Los Angeles Regional Water Quality Control Board

REQUEST TO MODIFY THE TURBIDITY COMPLIANCE MONITORING LOCATION - WATER REPLENISHMENT DISTRICT (WRD) ALBERT ROBLES CENTER (ARC) ADVANCED WATER TREATMENT FACILITY (AWTF), 4230 SAN GABRIEL RIVER PARKWAY, PICO RIVERA, LOS ANGELES COUNTY

Figure 1. Process Flow Diagram and Turbidity Monitoring Locations

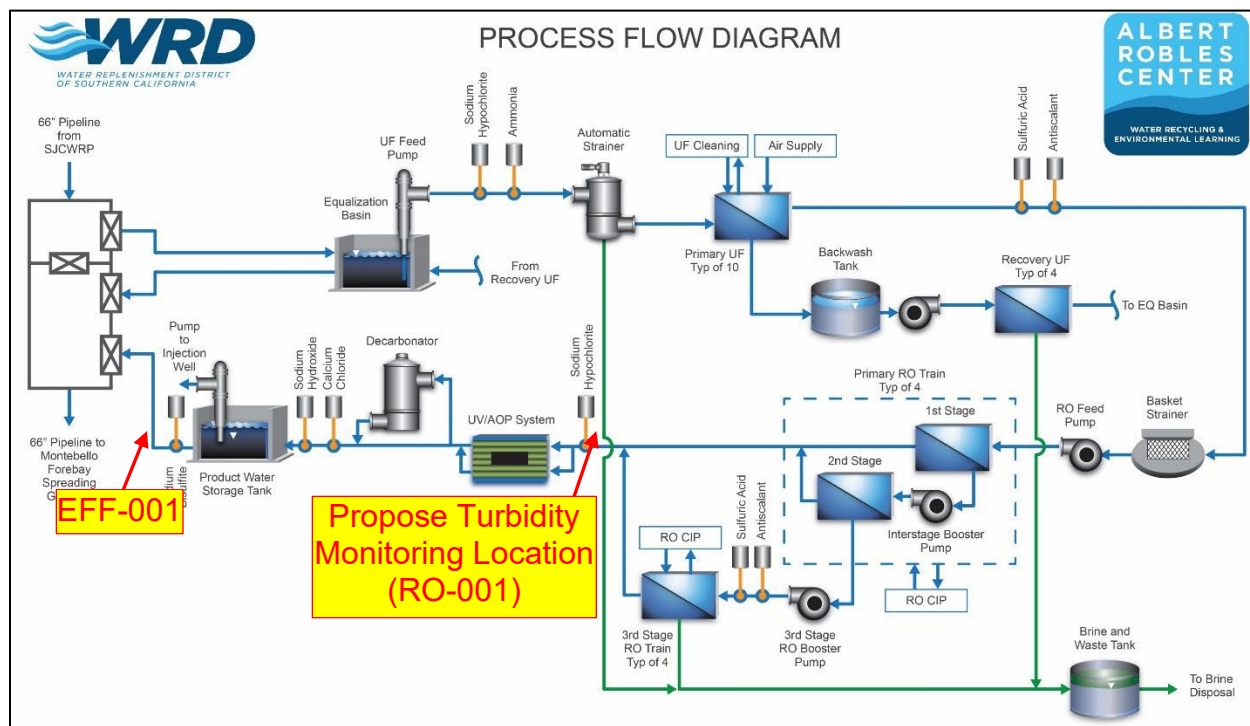
Due to these operational cost and storage capacity issues, WRD proposed that the compliance point for turbidity monitoring of the product water be relocated from EFF-001 to the reverse osmosis system effluent/permeate (RO-001) (Figure 1). This location meets permit requirements for pathogen removal and will prevent unnecessary alarms and plant shutdowns from false indicators of pathogens (as measured by turbidity) due to the injection of calcium chloride/calcium hydroxide.

After reviewing your request and consulting with State Water Board Division of Drinking Water staff, the Los Angeles Regional Water Board approves the request to relocate the turbidity compliance monitoring location from EFF-001 to the reverse osmosis system effluent/permeate (RO-001).
